## **ANNEX E TO PIR REPORT DATED APRIL 2017**

### **RNAV 1 SID route design for Route 4 in strong south to south-westerly winds**

**Figure 2 – Modified RNAV 1 SID (LAM 2X)**

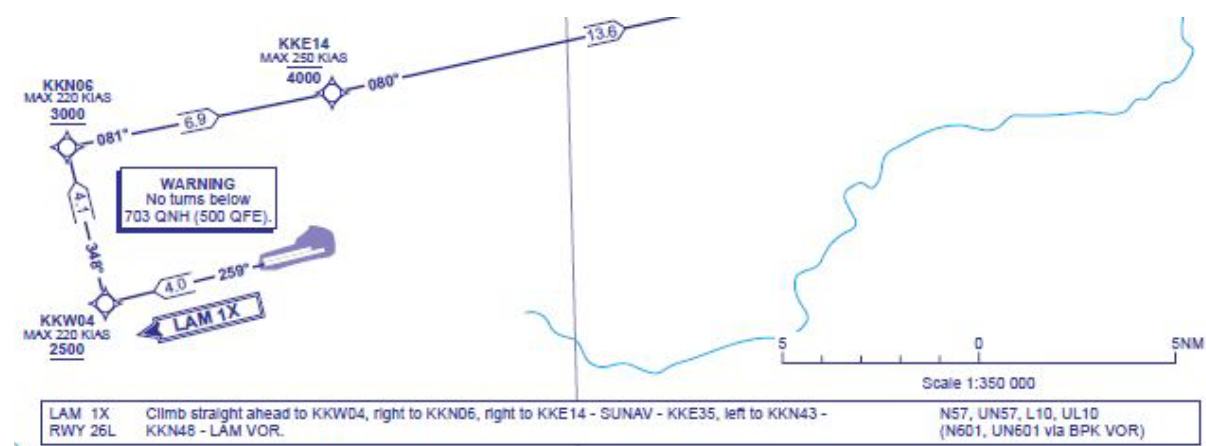
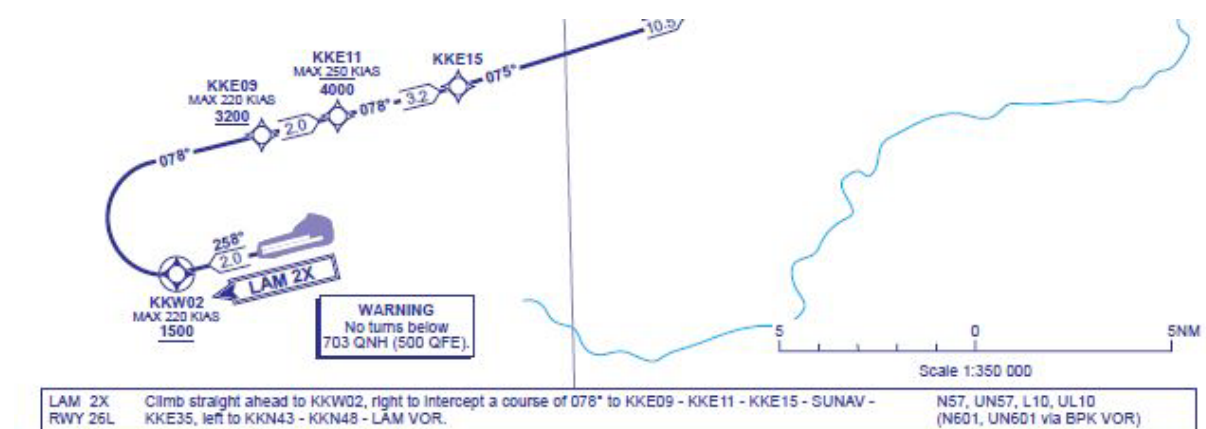
The modified SID retains the 220KIAS speed constraint in the wrap-around turn, but the route construction has been simplified in order to avoid the potential of waypoint bypass. Rather than the two fly-by turns at KKW04 followed by KKN06 used in the initial SID design – see Figure 1, the modified RNAV 1 SID – see Figure 2, commences a Course to Fix (CF) turn onto the downwind track, having over flown KKW02, a waypoint located 2.0NM along the runway track from the departure end of Runway 26L. The CF path terminator leg type provides a natural dispersion of aircraft tracks, taking as it does, account of aircraft weight, speed and bank angle authority in order to compute the path steering command to complete

The advantage of this design construction is that there is no minimum stabilisation distance to infringe between consecutive fly-by waypoints. The stabilisation distance is the distance the aircraft Flight Management System (FMS) requires in order to ensure completion of one fly-by turn before commencement of the next. The disadvantage of the modified RNAV 1 SID design is that it is left to individual FMS and aircraft manufacturers to compute the path from the commencement of the course change through to the downwind leg capture.

**Figure 3 - Aircraft Tracks relative to NPR on Modified RNAV 1 SID (LAM 2X) 25<sup>th</sup> November – 1<sup>st</sup> December 2016**

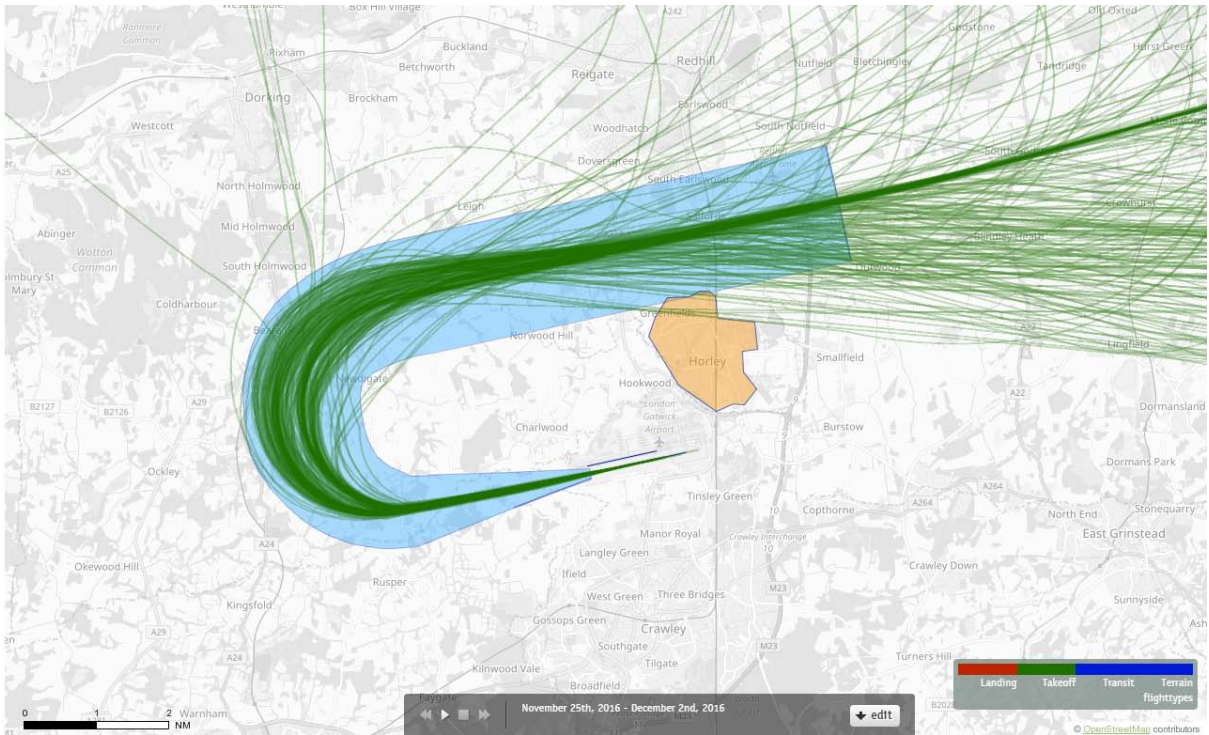
With a 220KIAS speed constraint and average wind conditions, the aircraft tracks remain spread within the Noise Preferential Route – see Figure 3. This accounts for the equipment and aircraft variability, and to a degree, the Standard Operating Procedures (SOP) applied by the Gatwick operators. However, as we've noted in Section 9, a slow speed coupled with high rate of climb as associated with certain A380 departures, can result in a very tight turn towards the capture for KKE09. And this is the difficulty with the CF path terminator, its natural dispersion can only be controlled through aircraft speed and that has to factor the effect of wind on groundspeed.

**Figure 4 - Aircraft Tracks relative to NPR on Modified RNAV 1 SID (LAM 2X) 17<sup>th</sup> – 23<sup>rd</sup> February 2017, including strong southerly wind days**

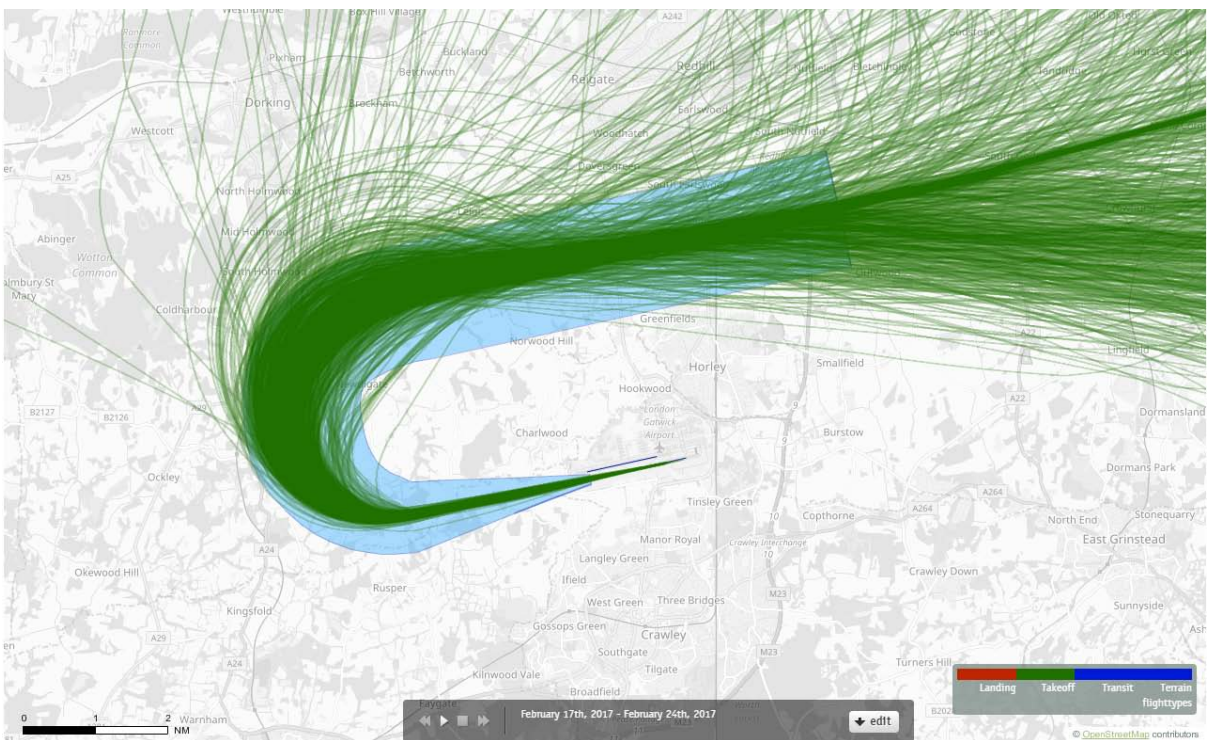
A strong southerly to south westerly wind translates as a cross wind prior to KKW02 to a tailwind afterwards. Despite the 220KIAS speed constraint, aircraft ground speed can pick up an additional 20 to 30 knots and the FMS uses this to compute the required angle of bank in order to make the capture of the downwind leg. At a given point, depending on aircraft weight, speed and available bank angle authority, the bank angle limits and the aircraft will drift outside of the turn. This is evident in Figure 4.

The only option is to avoid the ground speed from becoming too high, which means that as the wind is a constant, aircraft speed has to be kept below the speed constraint in order to provide speed margin and continued bank angle authority around the turn.

It should be noted that the procedure design is not at issue, rather the speed at which aircraft undertake the wrap-around turn. The aircraft speed management is under the control of the flight crew and the Standard Operating Procedures (SOP) which they adhere to. The Course to Fix (CF) path terminator used in the modified RNAV 1 SID design is a non-deterministic path terminator i.e., the path will vary depending on the input parameters, including wind. It does provide dispersion, but this dispersion is difficult to manage when aircraft and SOPs call for maximum use of automation.

Other options could include a version of the RNAV 1 SID with a slower speed constraint or use of an alternative procedure design using a more deterministic path terminator such as the Radius to Fix (RF) which allows for greater bank-angle authority. The first option is discussed below in the response from GAL, the second option would require further study, due the inherent track concentration afforded by the RF.
